# Brent Cross Cricklewood Development

Area Wide Walking and Cycling Study: Addendum 60473918-TP-RPT-091 Rev 002

# Appendix D. DRAFT STAPLES CORNER ALTERNATIVE PROPOSALS DRAWING BXCR-URS-SC-HW-SK-CE-00003 REV P01

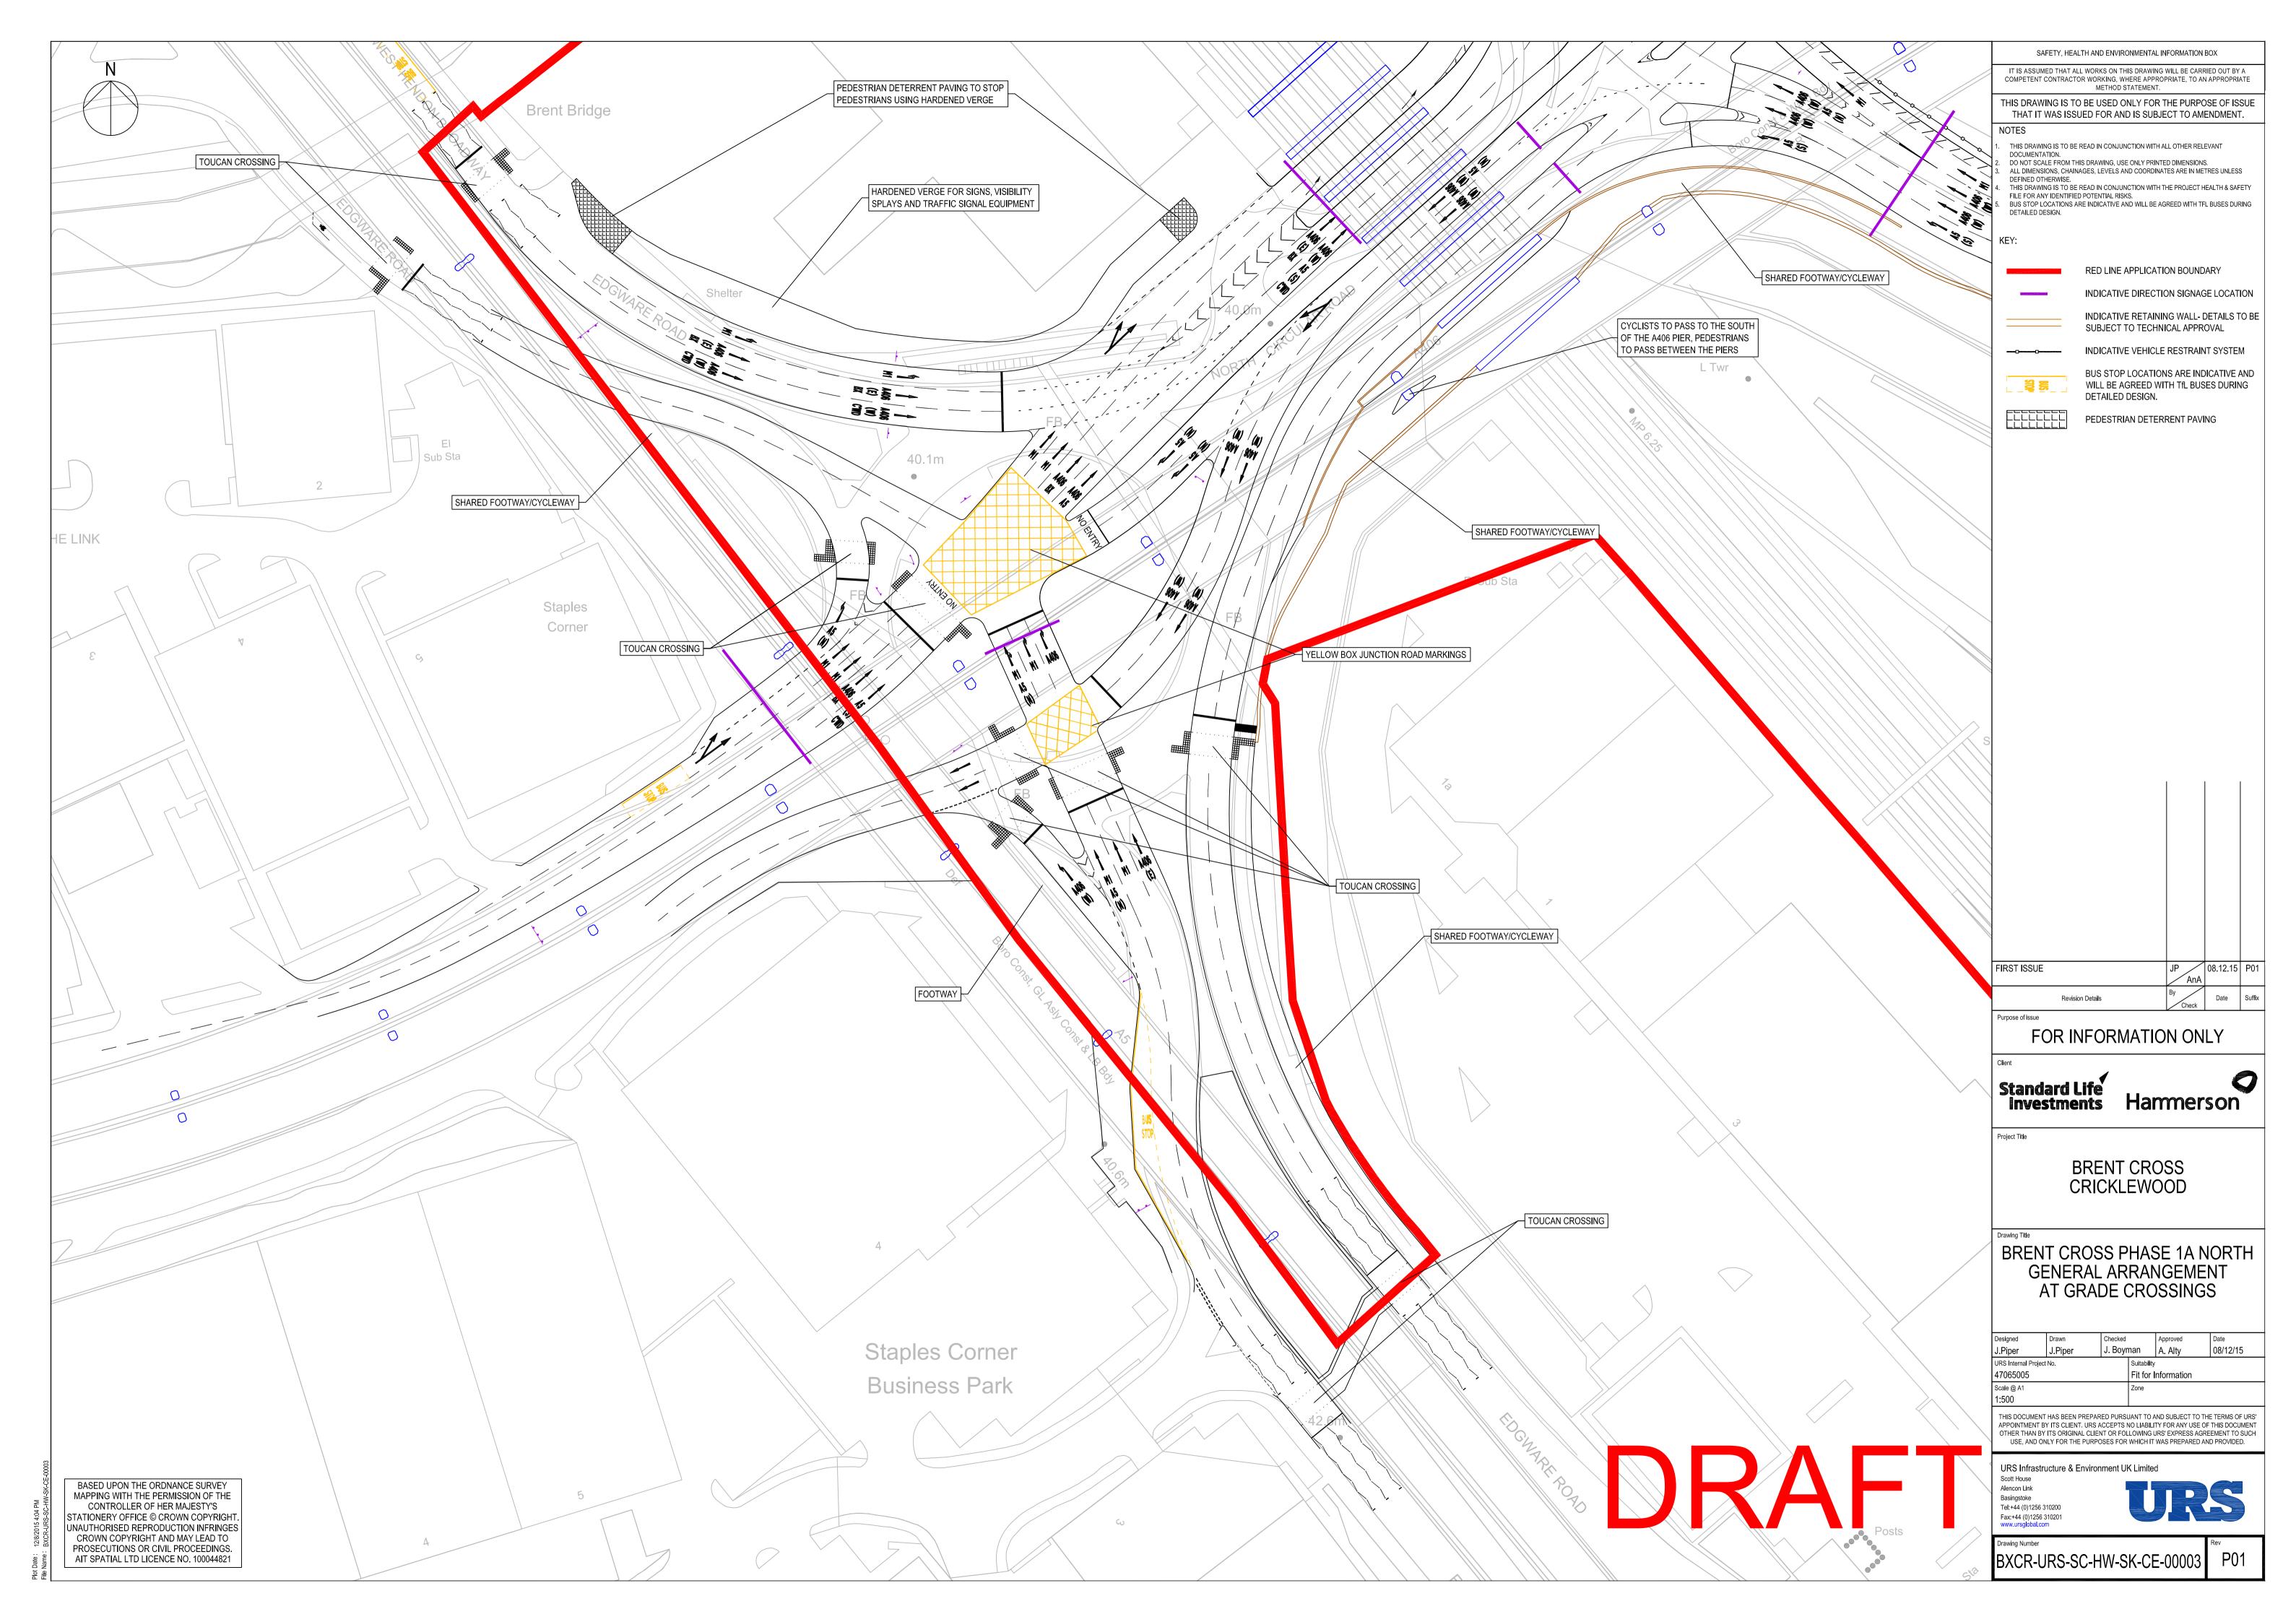
Under the draft alternative proposals, either the existing footbridges, ramps and steps at Staples Corner will be improved or they will be removed and replaced with a series of at-grade toucan crossings around the junction. Similarly either the pedestrian/ cycle bridge (Bridge B6) will be provided across the A406 or a series of at-grade toucan crossings are proposed.

Detailed discussions are ongoing with the highway authorities as part of the highway technical approval process, following which a decision will be made on the preferred scenario. The alternative DRAFT proposals for Staples Corner are shown in Drawing BXCR-URS-SC-HW-SK-CE-00003 Rev P01, in **Appendix D**.
